## Proposal of Amendment to Regulation 110-01

### **Rationale for the proposed amendments to Regulation No. 110 (CNG/LNG vehicles)**

## **Proposal - Alignment with ISO 11439:2013 - Proposed Revisions to:**

Regulation No. 110

Figure H.1 - Cylinder orientation and layout of exposure areas

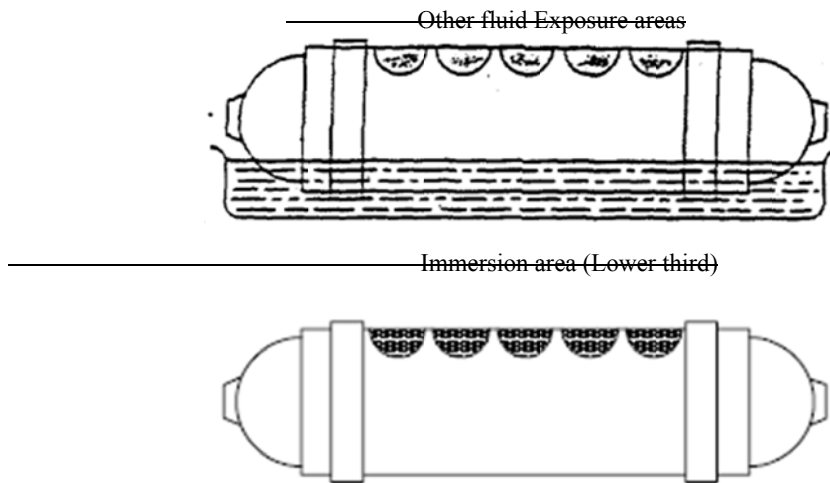
*The immersion part of the test was eliminated in ISO 11439 as the concentrated exposures to the 5 chemicals would provide a more severe test condition.*

The upper section will be divided into 5 distinct areas and marked for preconditioning and fluid exposure (see **Figure H.1**). The areas will be nominally 100 mm in diameter. The areas shall not overlap on the cylinder surface. While convenient for testing, the areas need not be oriented along a single line, but shall not overlap the immersed section of the cylinder.

Figure H.2

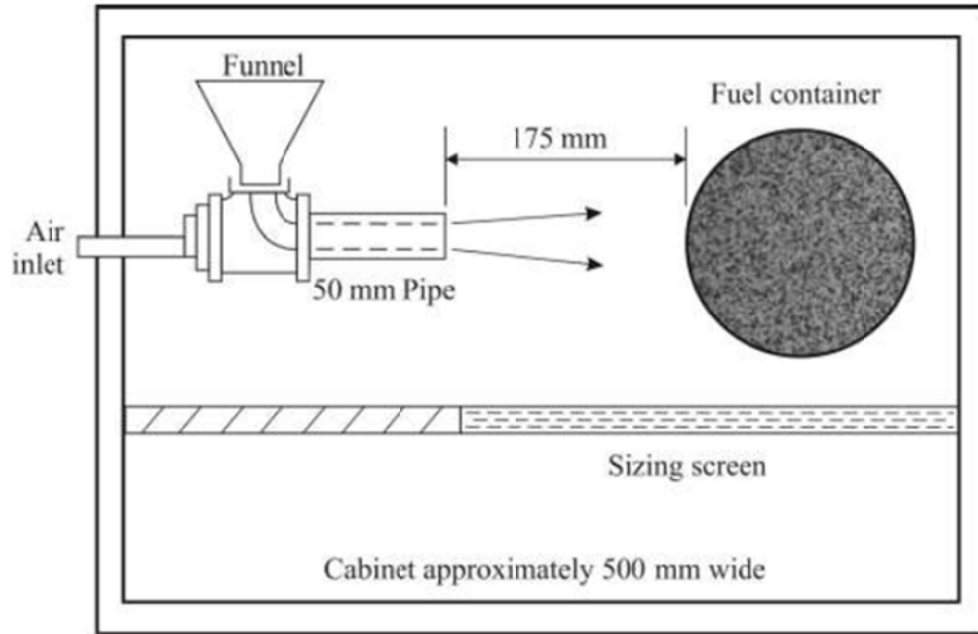
~~Machine constructed according to the design specifications shown in Figure H.2. This procedure for operation of the equipment shall follow that described in ASTM D3170, Standard Test Method for Chip Resistance of Coatings with the exception that the cylinder may be at ambient temperature during gravel impact;~~

*It was found in testing that the gravel impact had no apparent effect on the integrity of cylinders, or any protective coating – the pendulum impact was a much more severe test of a coating.*
